## Comments on Planning Applications 2021/1089 and 2021/1090

Many of the documents are the same, if with different filenames. Comments are common to both if appropriate.

**20211089 AIA Rpt Figures ACAD\_B028734 Barnsley West Tree Constraints Plan TCP17.pdf**

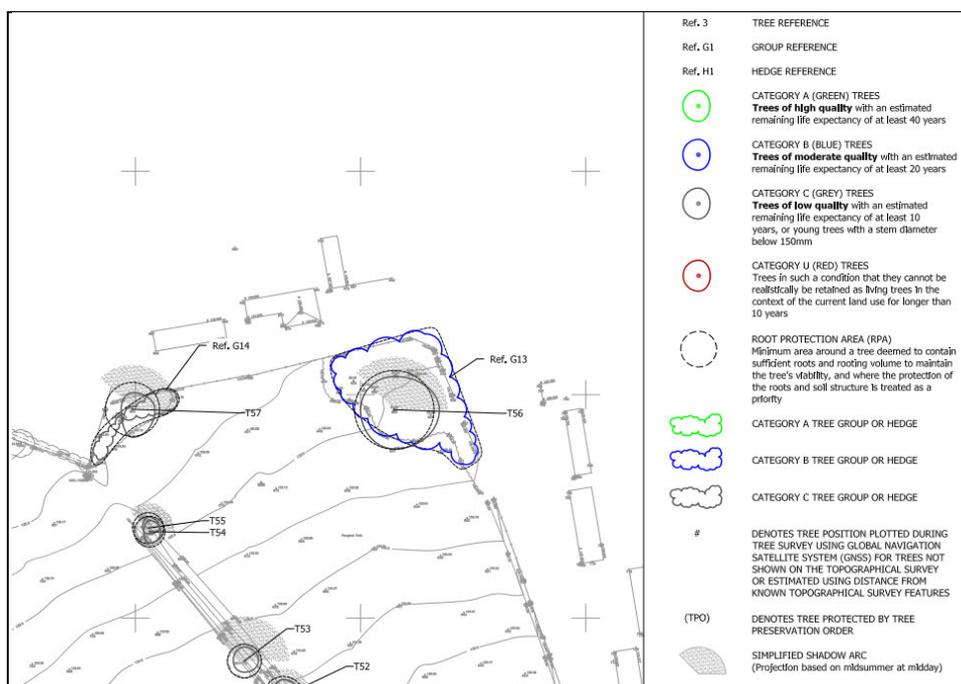
Trees in the corner of Wharfedale Rd/Colster Close are classed as trees of moderate quality with a 20 life span and some of them at least were planted as part of a planning consent, but all appear to have been slated for removal. Is this correct? If so, why?
